2. PCB hole recommendations differ

3. Housing Material Change

Affected Date Code: **11/15/2022**

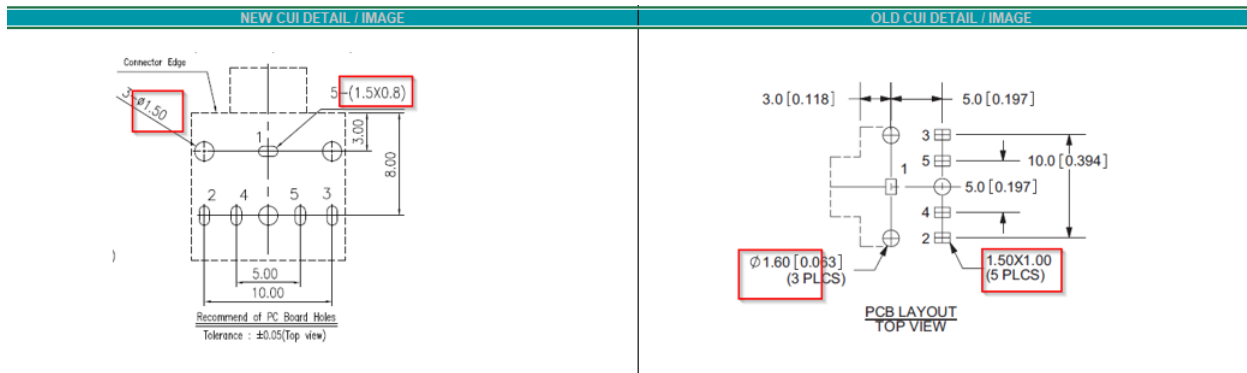
NEW CUI DETAIL / IMAGE			OLD CUI DETAIL / IMAGE		
DESCRIPTION	MATERIAL	PLATING/COLOR		MATERIAL	PLATING
terminal 1	C2680 t=0.30	silver	terminal 1	cold rolled steel	nickel
terminal 2	C5191 t=0.30	silver	terminal 2	copper alloy	tin
terminal 3	C5191 t=0.30	silver	terminal 3	copper alloy	tin
terminal 4	C2680 t=0.40	silver	terminal 4	brass	tin
terminal 5	C2680 t=0.40	silver	terminal 5	brass	tin
bushing	copper alloy	tin over copper	bushing	brass	nickel
cover	PBT (UL94V-0)	black	plastic	PBT	
housing	PBT (UL94V-0)	black
